**City of Avondale Estates**  
**Historic Preservation Commission**  
**COA Application Review\***

**March 2, 2026 HPC Meeting**

**Property Address:** 21 Kensington Road

## Project: 2026 Rowland Residence Rear Mudroom & Deck

*Design photos for proposed windows (exact same specs as windows replaced elsewhere in house)*

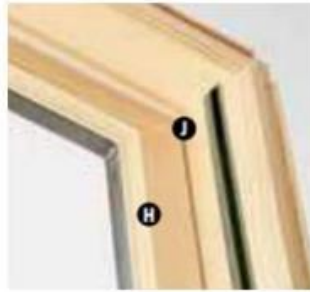
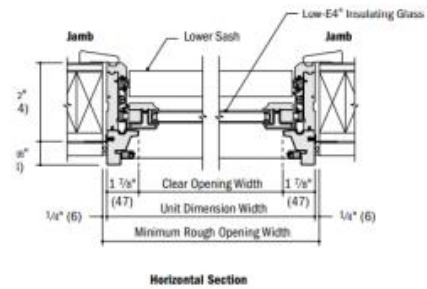
The porch's 4-over-4, double-hung wood windows are not original but may be considered historic elements. Replacement windows should be wood as proposed. The use of 4-over-4 sash instead of 6-over-1 should be considered to help maintain the porch's historic appearance.

- New enclosure materials on the porch should be wood rather than a synthetic material such as fiber-cement.
- Respect the porch's existing historic elements by using panels with a similar appearance to the beaded board panels and by considering the use of 4-over-4, double-hung, wood windows rather than 6-over-1.
- New rear entrance and basement doors should be wood rather than a synthetic material such as fiberglass.
